# INMAN SQUARE INTERSECTION IMPROVEMENTS PROJECT

Mid Cambridge Neighborhood Conservation District Commission  
May 7, 2018

Case: MC-5412  
Address: Vellucci Plaza

## MINUTES OF THE MID CAMBRIDGE NEIGHBORHOOD CONSERVATION DISTRICT COMMISSION

Concept 1: Eddy

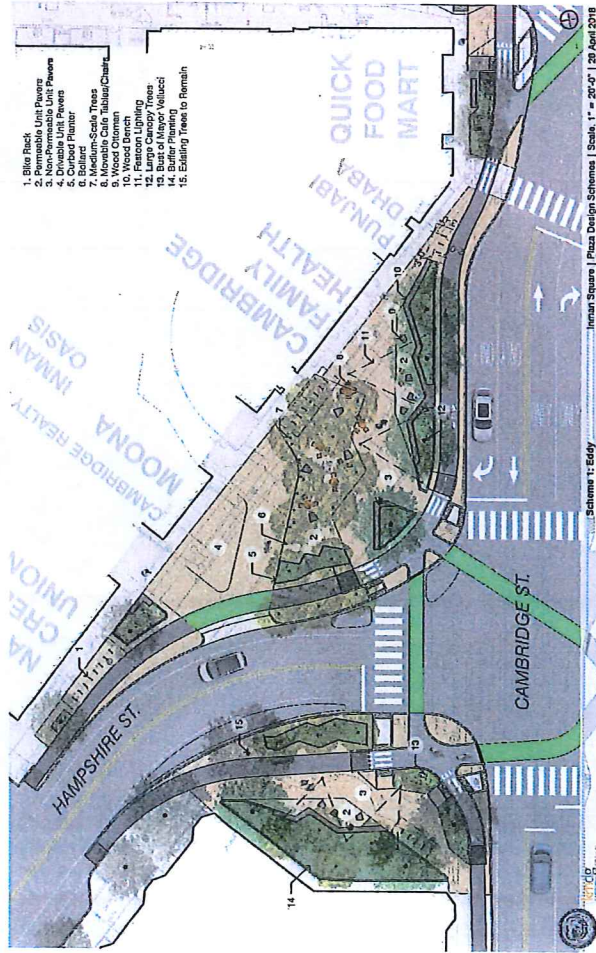
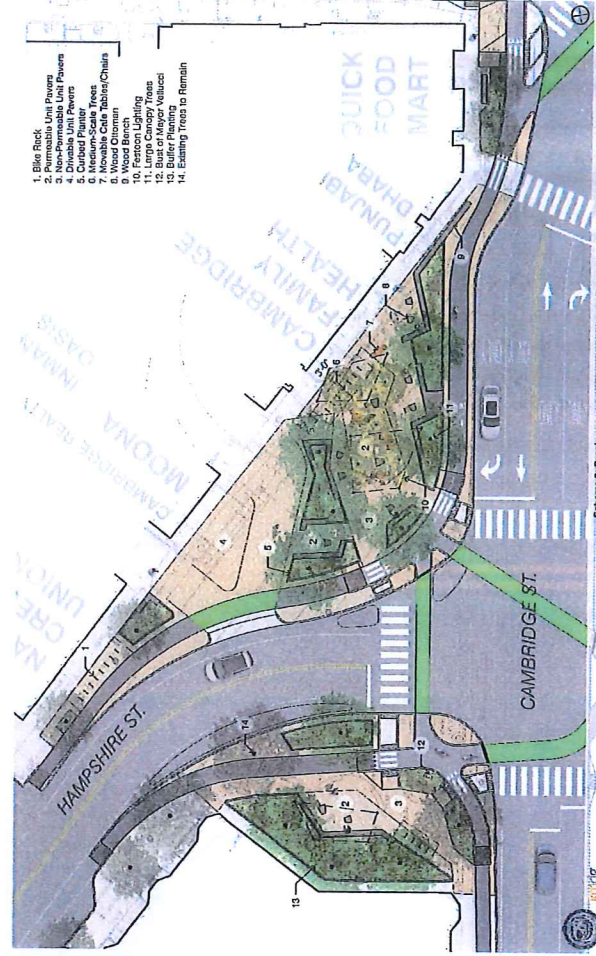
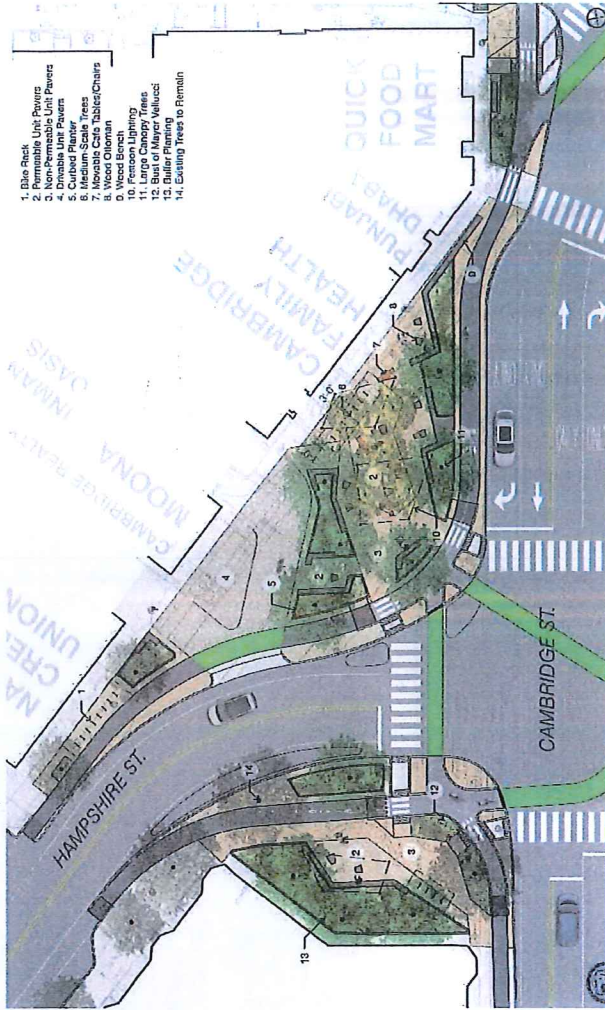
Mr. Redmon asked if the paving material could be expanded across the street to visually connect the two. Ms. Watkins said they try not to do that at signalized intersections.

Ms. Litchfield asked why planting stopped and did not extend along Hampshire Street. Mr. Friedman pointed out that there were existing driveways that limited some of the layout and they were considering special paving to have use of space when driveways were not being utilized.

Ms. Goodwin asked if either plan had more trees. Khaki replied that both plans were a rough layout and that it would depend specifically on the species as to what size would go in and how many could be placed within the areas. She added that they hoped to add variety to the area.

Mr. Redmon said he felt that the spaces should be treated with a field of paving, not a change to concrete or asphalt. Ms. Watkins said their plan was to have a tonal change, not a change in paving materials.
